4. APPENDICES

RESPONSES TO JUNE 26, 2008 SAN FRANCISCO PLANNING COMMISSION MEETING COMMENTS ON THE DRAFT EIR

7 Item No. 14, Case No. 2006.1308E,
8 Visitation Valley Redevelopment Program. This is a
9 public hearing on the Draft Environmental Impact
10 Report.

LR 12.01

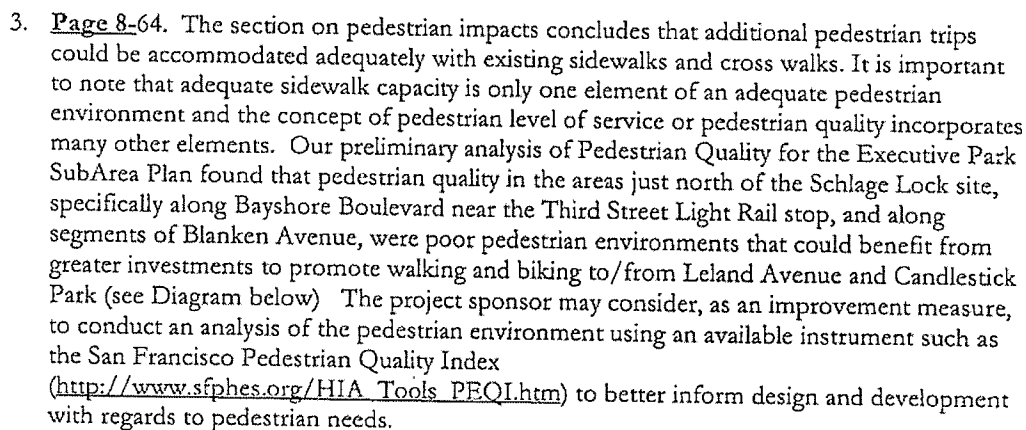
2. **Page 8-16.** The discussion of baseline conditions should include data on pedestrian-vehicle collisions in the project area. The map below illustrates pedestrian-vehicle collision rates in San Francisco along with relevant area level differences. SFDPH research documents that spatial differences in collision rates for pedestrians are dependent on population, commercial uses, high traffic volumes and street types. Providing a map of the location of pedestrian-vehicle collisions in the project area over the past 10 years would be helpful in identifying high hazard locations that could benefit from focused pedestrian design efforts. This would be particularly relevant given that traffic and pedestrian patterns may have changed significantly in the past year with the opening of the Third Street Light Rail near the project site. The SFDPH would be happy to provide such a map to the Redevelopment Agency for the final EIR.

From Page 37 of the *Executive Park Subarea Plan Health Impact Assessment Report*. Available online at: http://www.thehdmr.org/executive_park.php

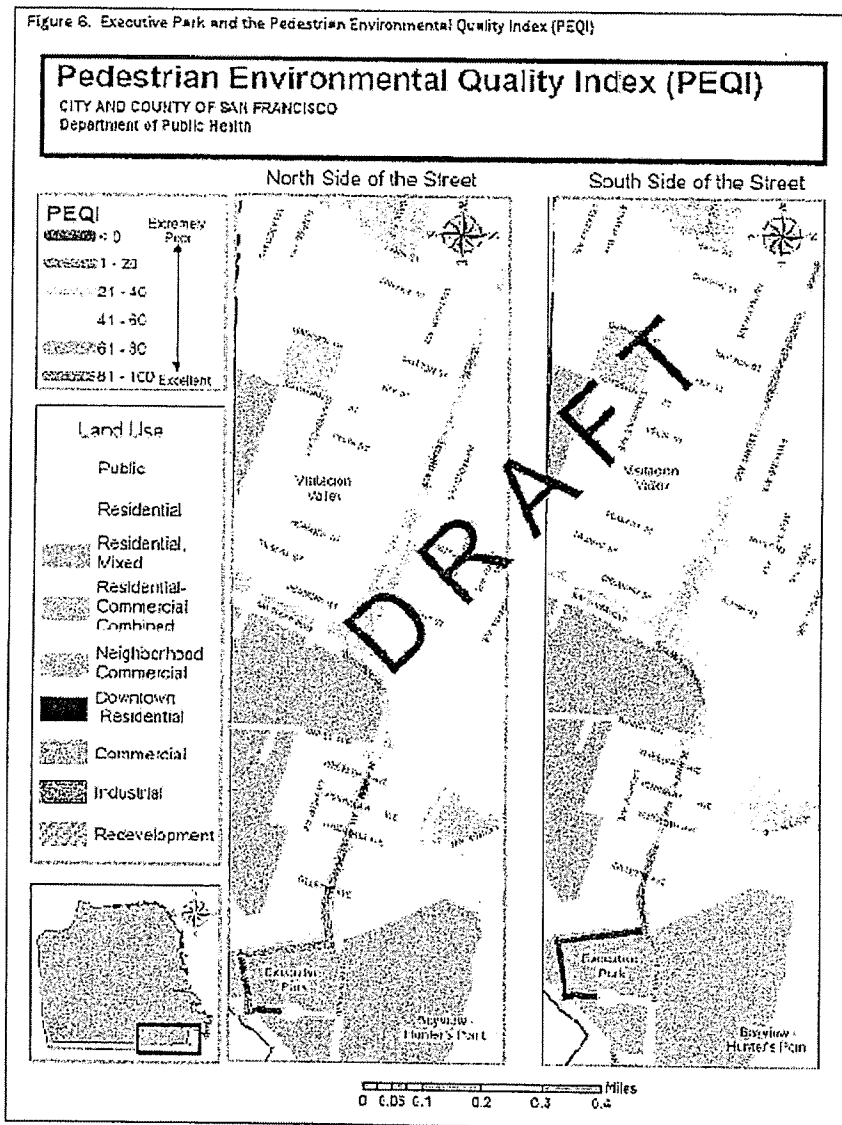
4. **Page 8-65.** In the section on pedestrian impacts, the DEIR identifies roadway intersection conditions that create potential for pedestrian-vehicle collisions. The DEIR subsequently documents that the project would increase both pedestrian and vehicle flows which suggests an increase in frequency of conflicts and collisions. These conditions and project-related effects on flows appear to be potentially significant impact requiring mitigation however, the DEIR does not acknowledge the potential for the conditions to result in a significant impact

Figure 1: Tunnel Avenue / Blanken Avenue – Lane Configuration and Signal Timing Plan

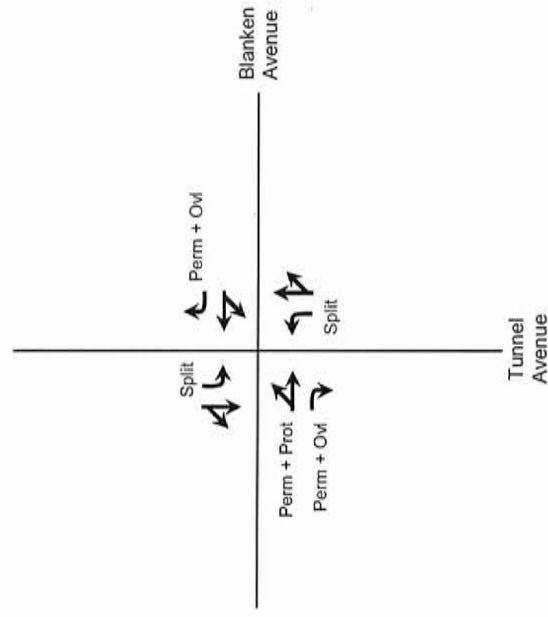
Transportation and Circulation--need to clarify transportation impacts and mitigations--traffic piece confusing and in need of clarification; makes it sound like Manhattan at its worst rush hour disaster; there should be more clarification; hard time envisioning the massive gridlock that is reflective in the EIR; needs to be some clarification on this.

Response: In response to this and similar comments regarding the need to provide a clear summary of the various DEIR-identified transportation network mitigation needs for the three analysis scenarios--Existing Plus Project, 2025 Cumulative Plus Project, and 2025 Cumulative Plus Project with Planned Regional Transportation Improvements, a summary chart entitled "Visitacion Valley Redevelopment Program--Roadway System Impacts and Mitigation Summary" has been formulated and included in Appendix 4.5 (Supplemental Transportation Analysis Information) herein. The chart lists each study intersection, freeway segment and freeway ramp addressed in the DEIR traffic analysis, and summarizes associated impact and mitigation findings for each of the three analysis scenarios.
